AGENDA FOR THE CANTERBURY BANKSTOWN LOCAL PLANNING PANEL MEETING

8 October 2018 - 6.00pm

| ITEM 1 | 154 Hector Street, Chester Hill |
| | Conversion of existing unauthorised outbuilding to a secondary dwelling |

Wall Height

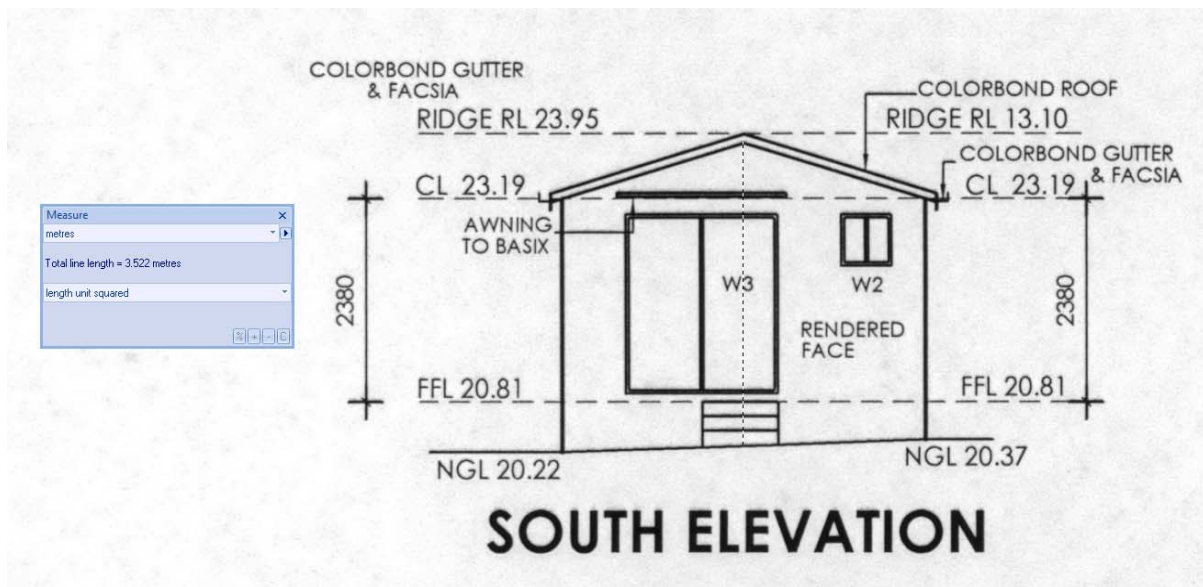
Clause 3.4 of Part B1 of the BDCP 2015 requires the secondary dwelling to have a maximum wall height of 3m. The wall height of the proposed secondary dwelling measures at 3.5m, causing a non-compliance of 0.5m above the maximum allowable wall height of 3m. The non-compliance arises due to the nature of the roof form / gable end wall found on the southern (rear) elevation.

It is considered that enforcing compliance with the abovementioned clause in relation to wall height would be unreasonable. The wall height control is like for like in terms of wall height for secondary dwellings and outbuildings, from which in this case the wall height for the existing outbuilding displays an existing non-compliance.
